**CITY OF PALO ALTO  
CITY COUNCIL  
Special Meeting  
Monday, April 29, 2024  
Council Chambers & Hybrid  
5:30 PM**

2. Review of Rail Grade Separation Alternatives for the advancement of the alternatives into the preliminary engineering and environmental documentation phase; CEQA status – statutorily exempt under CEQA section 15262 (feasibility and planning study).

## City Council Staff Report

## Churchill Closure with Mitigations - Option 1

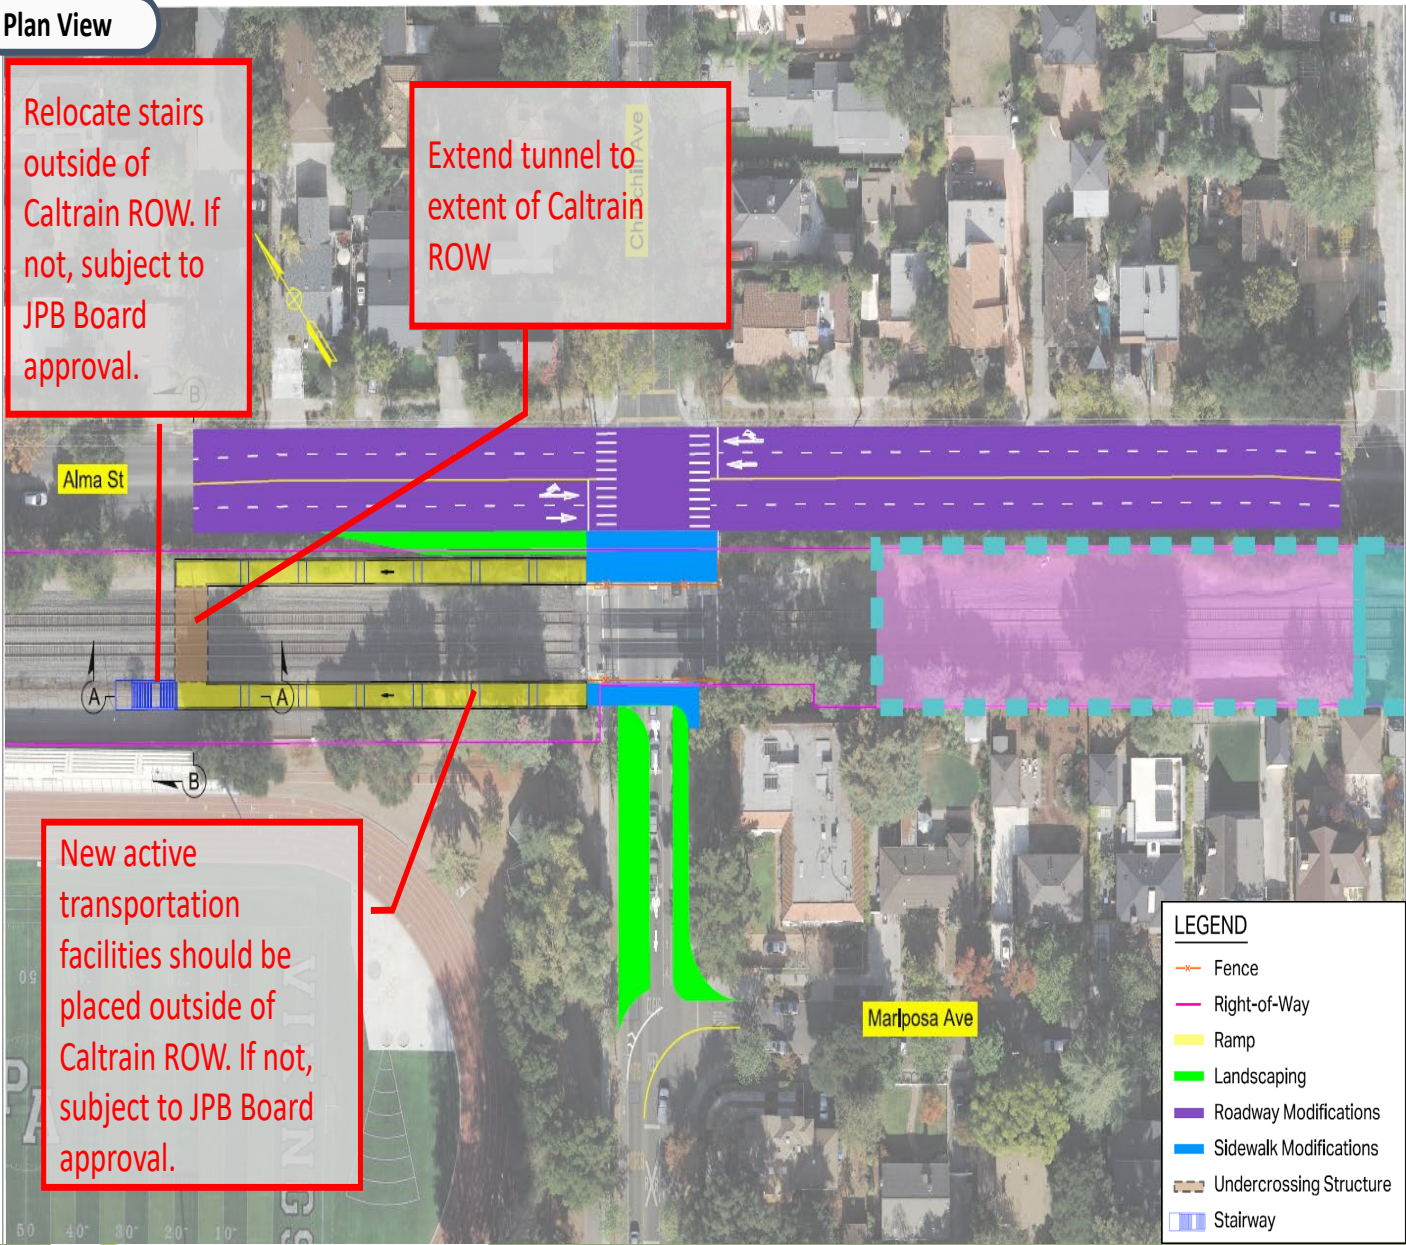
- New active transportation facilities should be placed outside of Caltrain ROW. If not, they are subject to JPB Board approval

# Summary of Comments – Meadow Dr - Hybrid

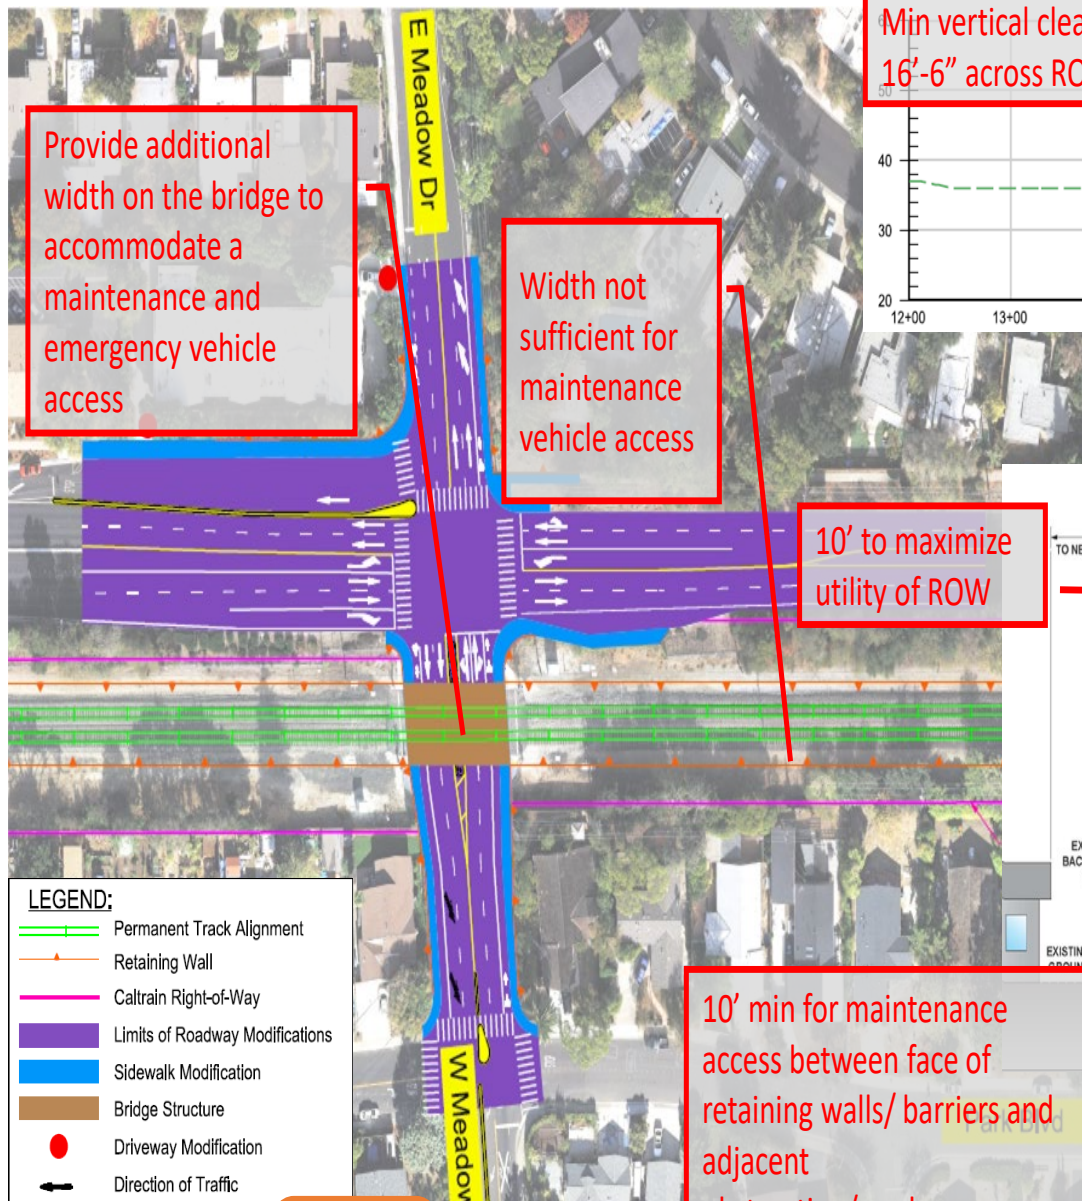
Provide additional width on the bridge to accommodate a maintenance and emergency vehicle access

Width not sufficient for maintenance vehicle access

# Summary of Comments – Charleston Rd - Hybrid

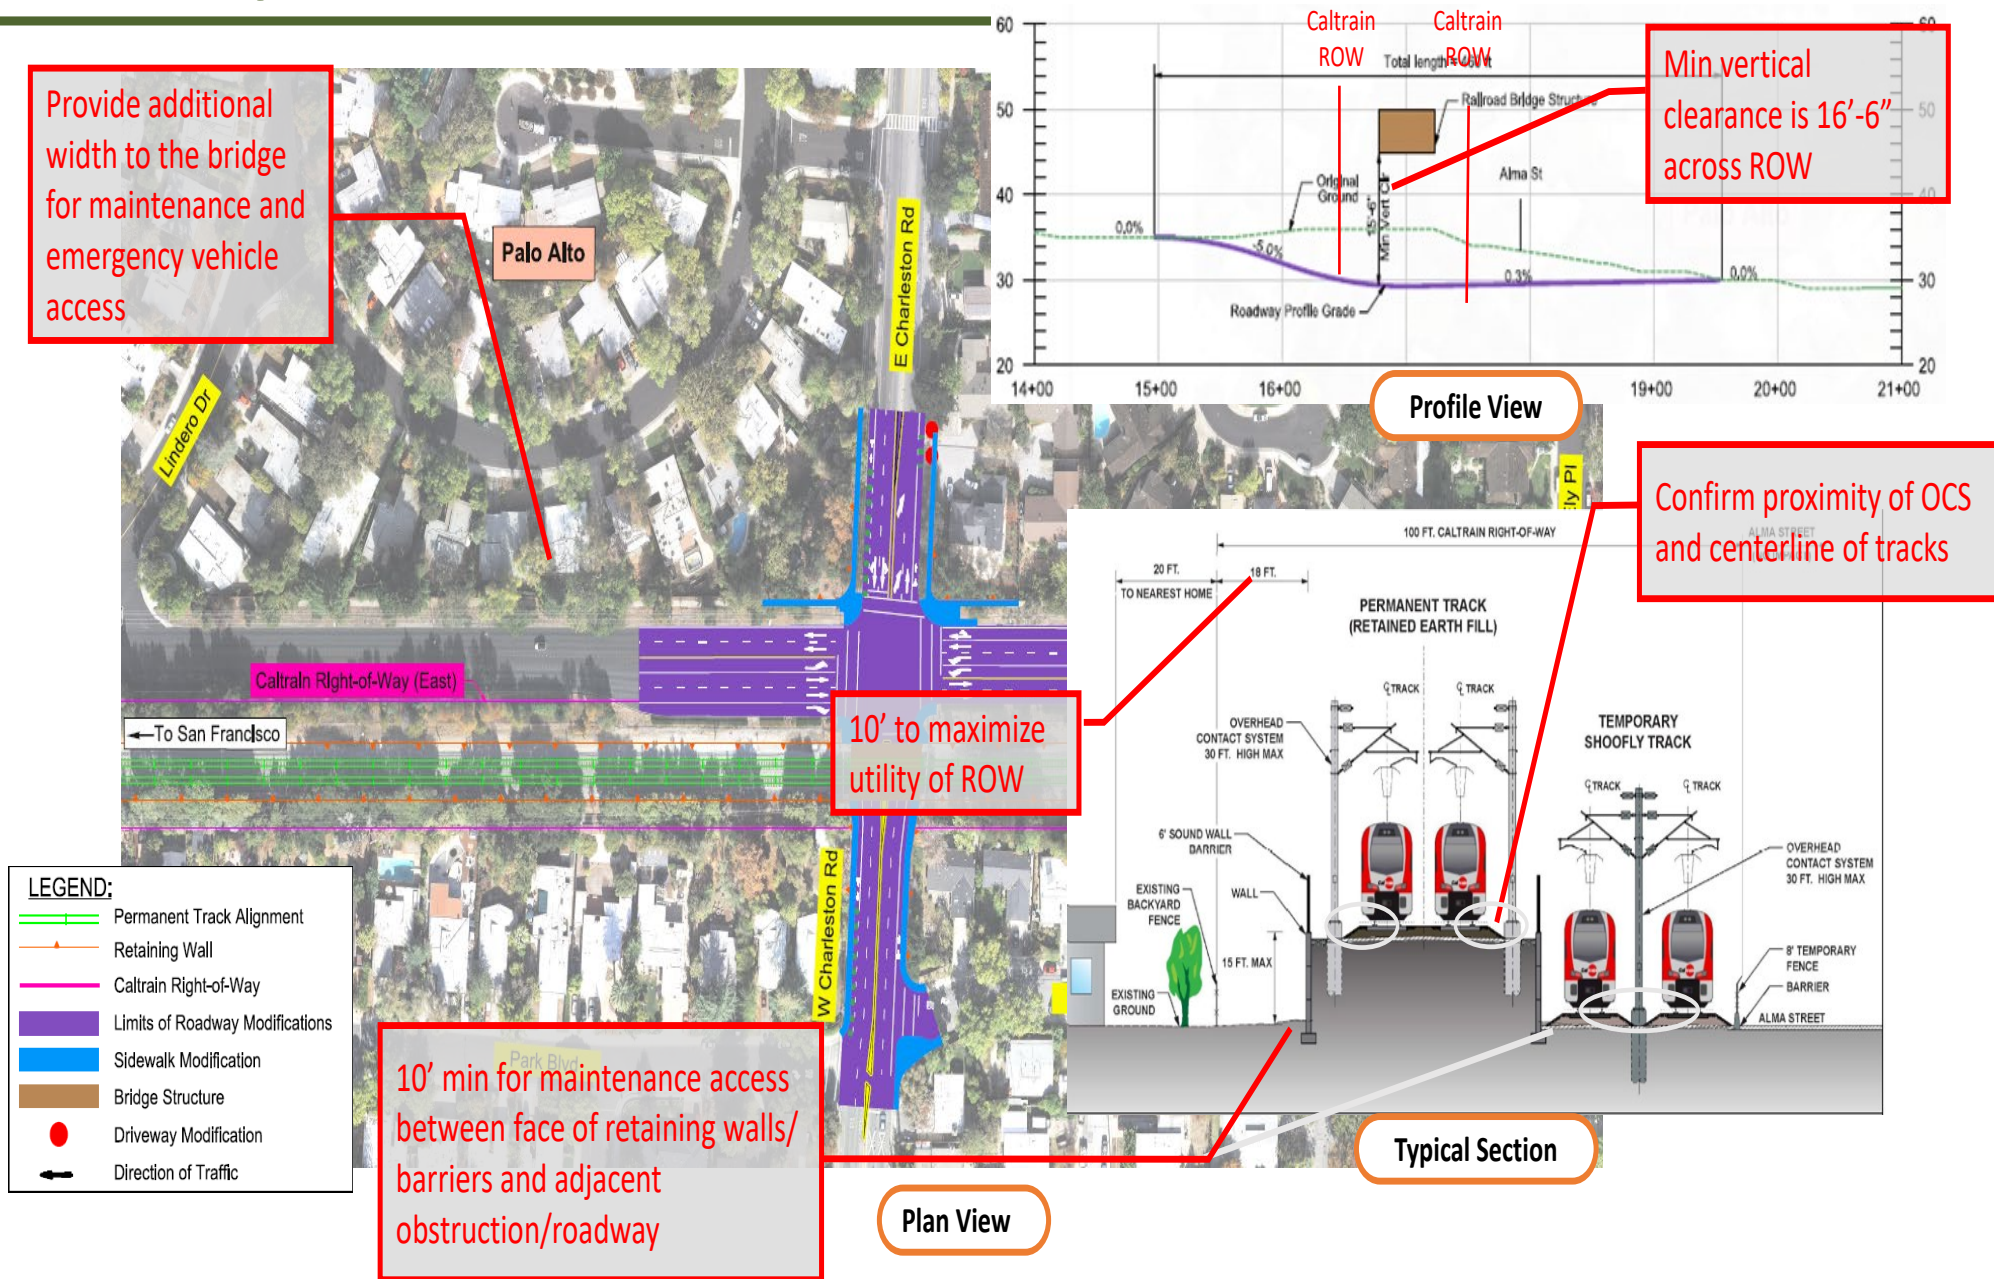
- Provide 16'6" vertical clearance requirement for the extent of the Caltrain ROW.
- Adjust retaining walls to accommodate 4-track and 4-track transitions.
- Provide sufficient space (10' min) for maintenance vehicle access and maximize utility of Caltrain ROW.
- Provide sufficient space (10' min) clearance from the walls to the roadway or structures
- Construction of permanent MSE walls to be at 20' from center of shoofly track—constructability clearance from OCS and active railroad.

Provide additional width on the bridge to accommodate access road for maintenance and emergency vehicles

# Summary of Comments – Meadow Dr & Charleston Rd - Viaduct

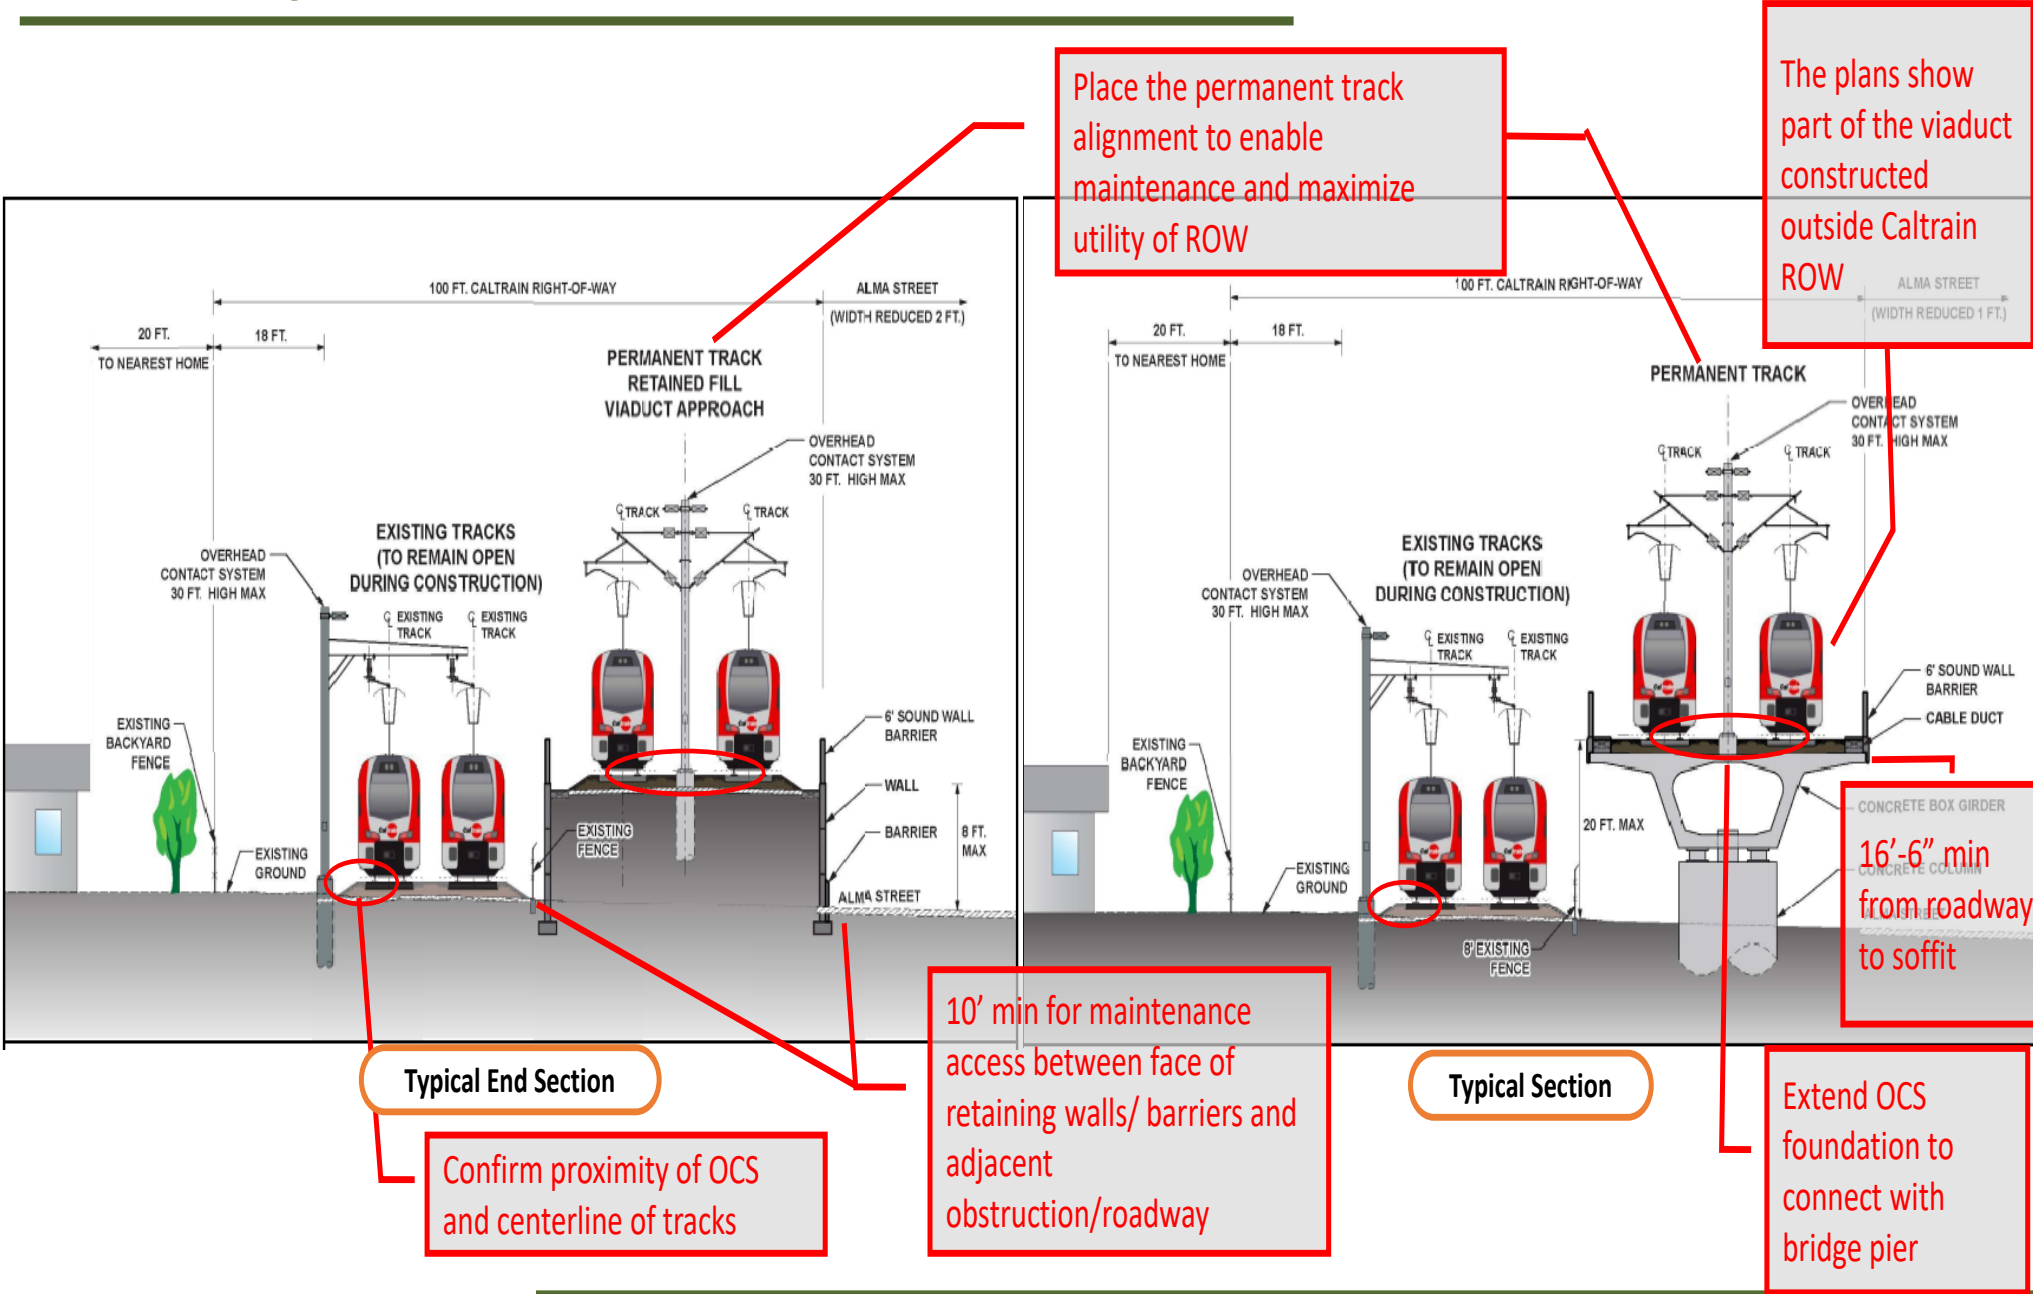
- Provide 16'6" vertical clearance requirement for the extent of the Caltrain ROW—will require reprofiling of roadway and/or Caltrain tracks.
- The vertical dimension from the top of the roadway to the top of the rail should be 24' instead of 20' to accommodate 5-foot bridge depth and 2'-6" Rail.
- Provide bridge width to provide access for Caltrain maintenance and emergency vehicles.
- Adjust retaining walls to accommodate 4-track and 4-track transitions.
- Provide sufficient space (10' min) for maintenance vehicle access and maximize utility of Caltrain ROW.
- Construction of permanent MSE walls to be at 20' from center of shoofly track—constructability clearance from OCS and active railroad.
- Roadway design to meet Caltrans HDM/AASHTO 'Greenbook'/AASHTO 'Highway Safety Manual'
